TECHNICAL BULLETIN	
	July 2001 TB 1903
Mfg:	FORD
Model:	F-SERIES
Liter:	4.2L
V I N:	2
Year:	97-08

Revised Head Bolt Torque Procedure On
1997-2001 Ford 4.2L VIN 2 Engines

Bulletin Diagram: FIGURE 1, CYLINDER HEAD TORQUE SEQUENCE - CYLINDER HEAD

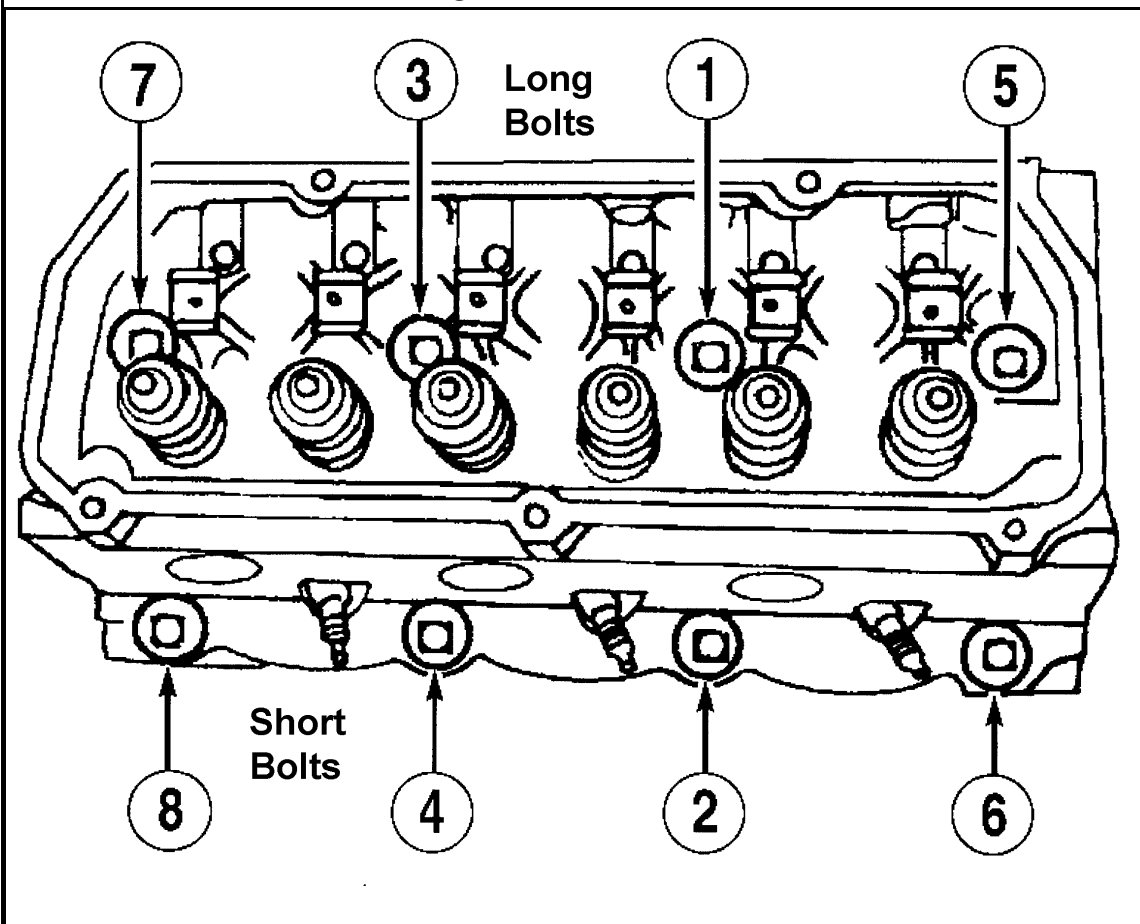
To install this assembly correctly, following the steps listed below, observing the sequence shown in Figure 1. Doing so, will minimize the likelihood of head gasket failures due to improper clamping load. Before installation, lubricate all bolts with clean Super Premium SAE 5W-30 Motor Oil XO-5W30-QSP or equivalent meeting Ford specification WSS-M2C153-G.

*Caution: Do not loosen all of the bolts at one time. Work with one bolt at a time in the sequence shown in Figure 1 below. Failure to loosen bolts in proper sequence may cause the cylinder head to warp excessively.

Step 1) Torque all bolts in sequence to 14 ft/lbs. (19 Nm)

Step 2) Torque all bolts in sequence to 29 ft/lbs. (39 Nm)

Step 3) Torque all bolts in sequence to 36 ft/lbs. (49 Nm)

Step 4)

Long bolts: (One Bolt at a time in sequence 1,3,5,7)

a)* Loosen long bolt and back out 3 revolutions.

B)* Retorque long bolt 30-36 ft/lbs (41-49 Nm).

C)* Rotate long bolt an additional 175-185° degrees.

D)* Go to the next bolt in sequence.

Short bolts: (One Bolt at a time in sequence 2,4,6,8)

a)* Loosen short bolt and back out 3 revolutions.

- b)* Retorque short bolt 15-22 ft/lbs (20-30 Nm).
- c)* Rotate short bolt an additional 175-185° degrees.
- d)* Go to the next bolt in sequence.
